## ***Interactive comment on “Empirical estimation of present-day Antarctic glacial isostatic adjustment and ice mass change” by B. C. Gunter et al.***

**B. C. Gunter et al.**

Received and published: 23 November 2013

**Fig. 1.** Geographical comparison of degree 1 mass change trends, in units of equivalent water height, for the coefficients by Swenson et al (2008), right, and Cheng et al (2010), left.

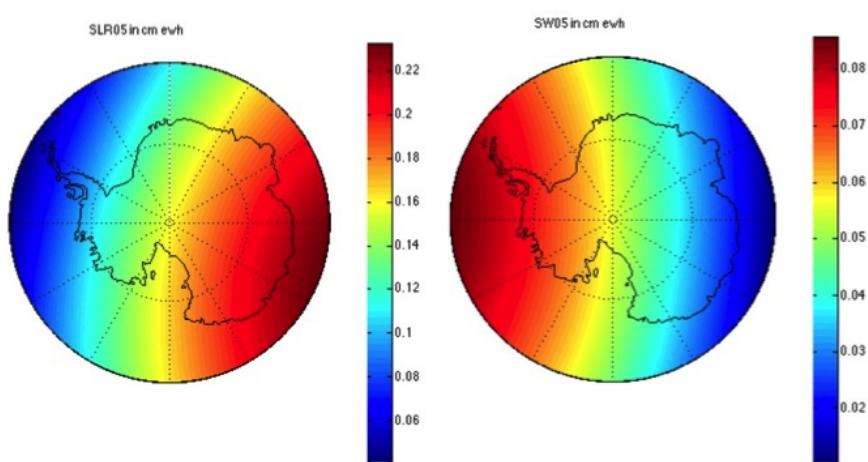
P3513L17: Degree-1 does not only have a z-component over Antarctica. Therefore, a tilt between EA and WA will remain, causing a bias in the mass / GIA estimate between both regions. As different degree-1 trends show different tilts, I would encourage the authors to apply the estimate from Cheng et al. 2010 in addition to Swenson et al. 2008 (<http://grace.jpl.nasa.gov/data/degree1/>). This should be a fairly simple additional calculation.

Taking the Cheng et al (2010) and Swenson et al (2008) coefficients as an example,

Fig. 1 of this response plots the trend over Antarctica derived from the two solutions. Note the substantial difference in phase and amplitude. In addition, the two solutions different in the way that GIA is treated...Swenson et al. 2008 remove GIA for the estimation of the degree-1 coefficients, whereby SLR is observing "full-geocenter" motion without any GIA corrections applied. As a result, these two time series are not directly comparable.
